CAPITAL PROGRAM SERVICES
5750 ALMADEN EXPRESSWAY
SAN JOSE, CA 95118-3686
TELEPHONE (408) 265-2600
FACSIMILE (408) 979-5631
www.valleywater.org
scvwdplanroom@valleywater.org

March 24, 2021

ADDENDUM NO. 7
TO CONTRACT DOCUMENTS FOR THE
ANDERSON DAM TUNNEL PROJECT
Project No. 91864005 Contract No. C0663

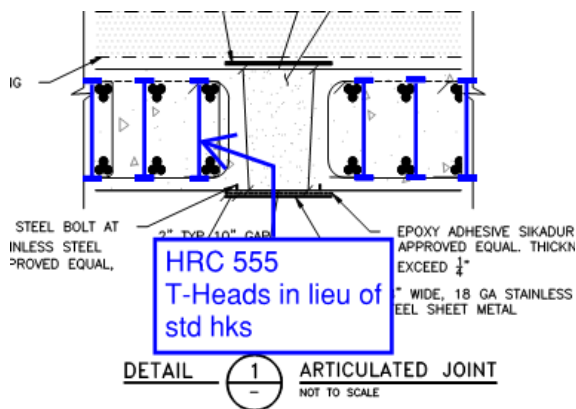
Please confirm the hoops shown around the steel pipe on sheet S-051 can be lap spliced, not resistance welded?

Yes, the rebar is spliced.

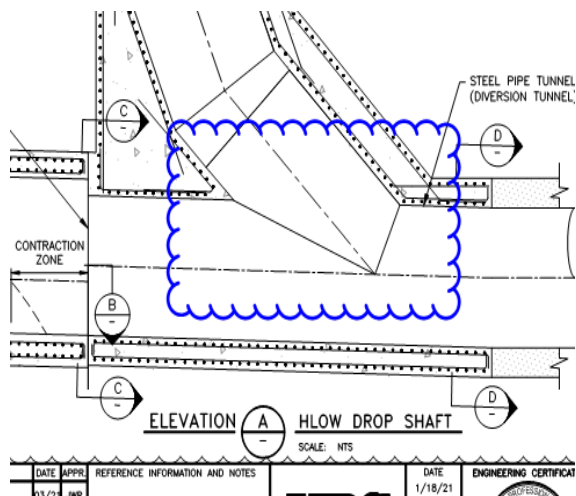
Please confirm it's an acceptable option to provide HRC 555 T-heads in lieu of standard hooks in an effort to eliminate congestion. See below:

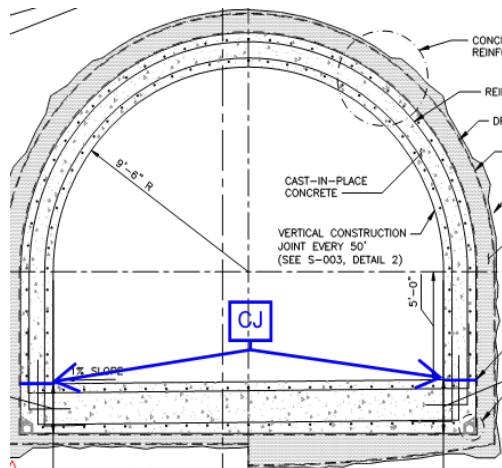
Please provide rebar interface details at the HLOW drop shaft where it meets the concrete encased steel pipe tunnel liner. Ref. S-051.

The details are shown on Drawing S-051, Sections A and D.

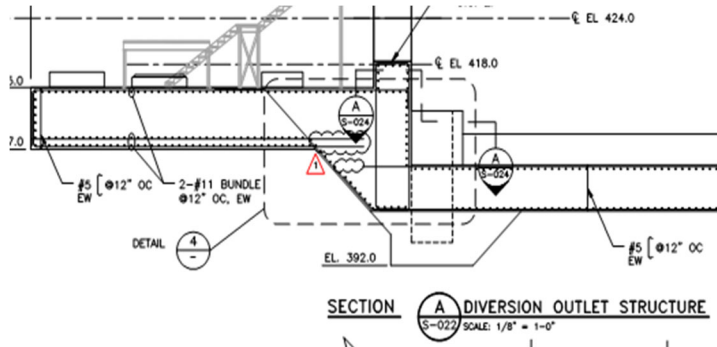
The section below (A on Sheet S-023) has a callout for the 8 ft. mat which is confusing. It call for 2 -#11 Bundle @ 12" OC E.W., and points to single bars in three layers. Please provide clarification.
